**PUBLIC INTEREST REVIEW FOR GROUND WATER APPLICATIONS**

SUBJECT: Application G- 16826 Supersedes review of none  
Date of Review(s)

A. GENERAL INFORMATION: Applicant's Name: Barry & Tammy Wilkinson County: Harney

Table showing water-level data for State Well HARN 547, State Observation Well # 169

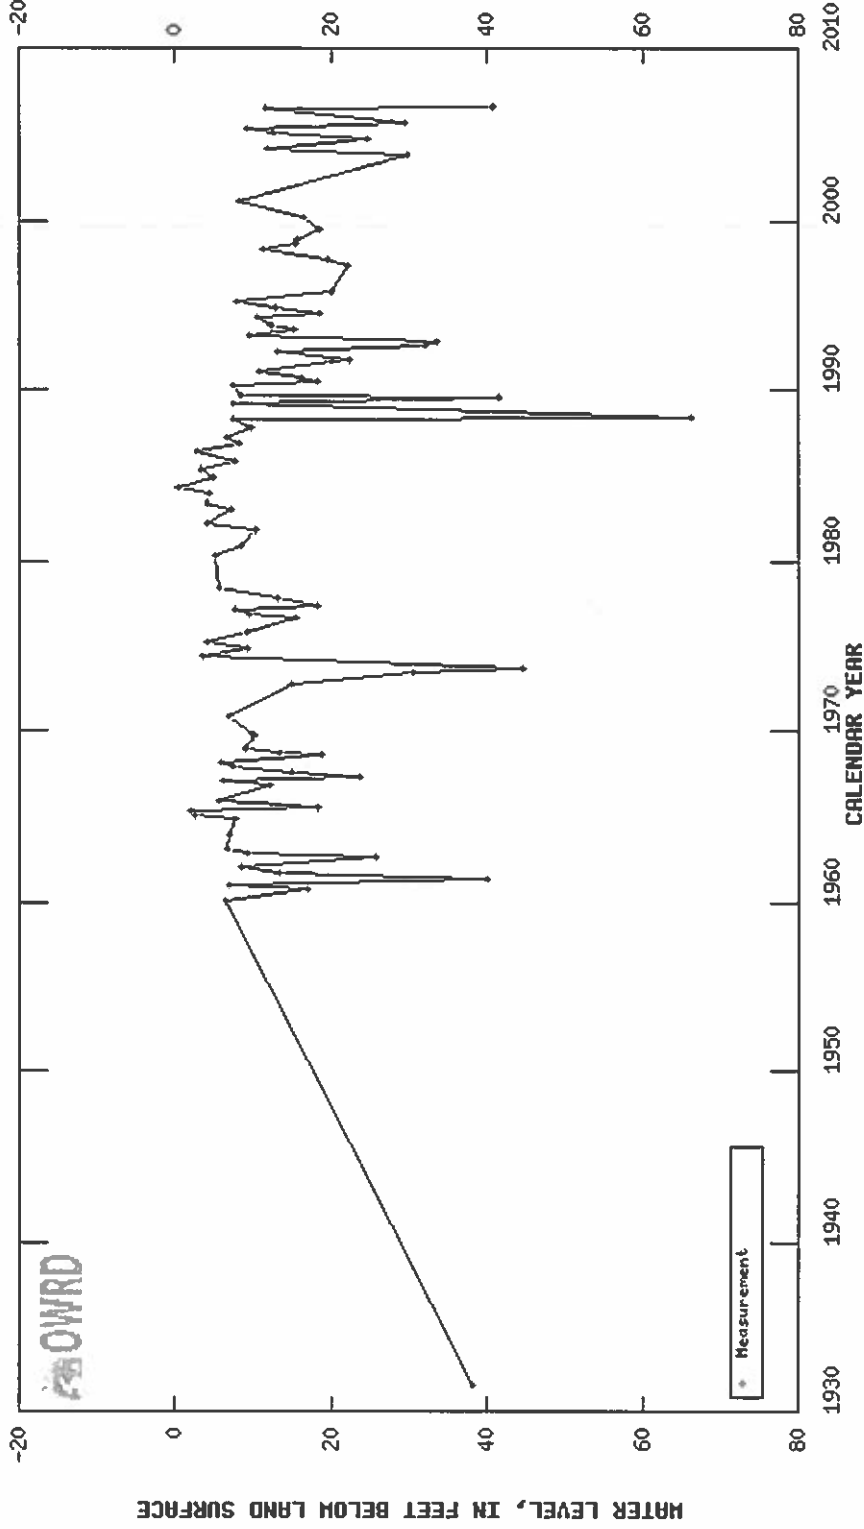
The closest wells with ground water level trend data are wells HARN 547 in T23S/R32E-sec 07 (about 10.5 miles to the west) and HARN 741 in T23S/R34E-sec 31 (about 8.2 miles to the southeast). Both are completed in sediments, and both are in the same sub-basin as the applicant’s well. The ground water level data for HARN 547 is from 1960 to 2006 and for HARN 741 is from 1974 to 2006. The ground water level trend at each site show seasonal and climatic influences. A possible net decline of less than 5 feet may have occurred at both sites. Interestingly, no recovery of the annual trend is apparent from 1996 to 1999, a generally wetter than average period in Oregon. Seasonal ground water level fluctuations range from 10 to 40 feet. This could adversely impact the use of shallow wells, but likely not adversely impact the use of deeper wells.

**Transient Stream Depletion (Jenkins, 1970; Hunt, 1999)**  
**Proposed Well 1 (G-16826) to Malheur Slough**

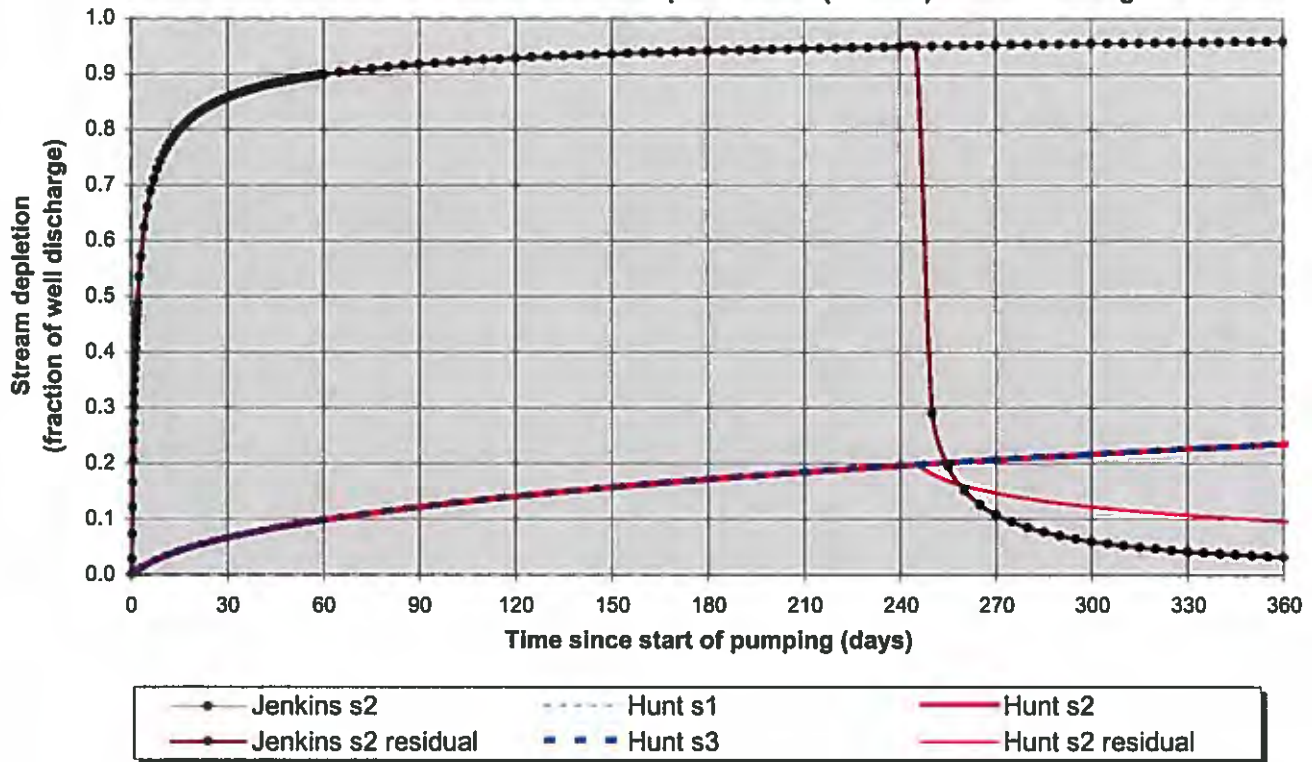
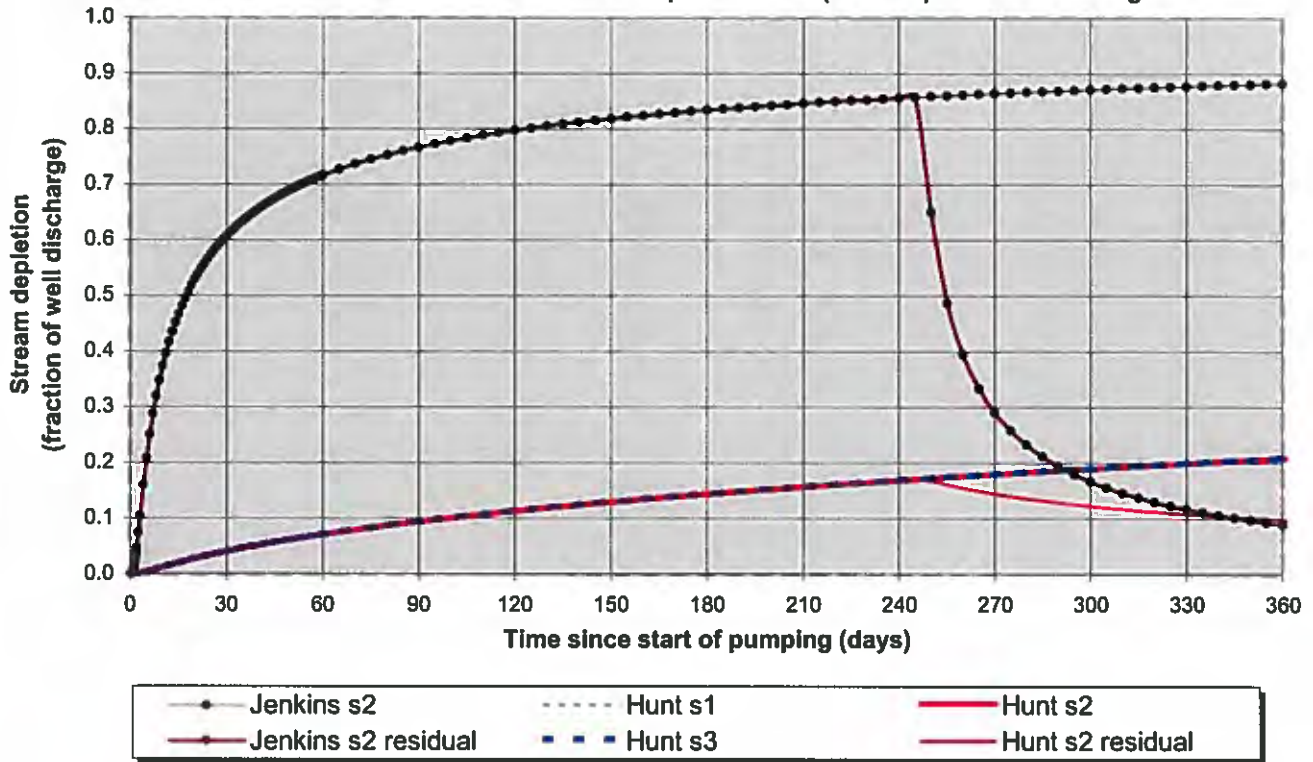
The distance from owner proposed well 1 Malheur Slough is less than 1 mile (3,800 feet).

Potential for substantial interference must be assumed given the proposed pumping rate exceeds 1 percent of the natural flow (80 percent exceedance).

Hunt (1999) was used to calculate the interference at Malheur Slough given the well will likely not penetrate the basin fill sediments. The values used for the calculations are conservative and appropriate until better values become available. The calculations used a transmissivity of 7,500 ft<sup>2</sup>/day which is consistent for Eastern Oregon basin fill transmissivities noted by Gonthier (1985) and transmissivity values derived from specific capacity data from wells in T23S/R32.57E-sec 10, 13, 14, 15, 22, and 24 (HARN 564, HARN 641, HARN 642, HARN 645, HARN 648, HARN 649, HARN 650, HARN 651, HARN 657, HARN 1870, HARN 50054, HARN 50491, HARN 50514, and HARN 51204). Additionally, the calculation used an assumed intermediate storage coefficient (0.001). The hydraulic conductivity assigned to the bed of the tributary is 0.20 feet/day.

C6. SW / GW Remarks and Conditions: Recommend conditions 7B, 7F, and 7N if a permit is issued.
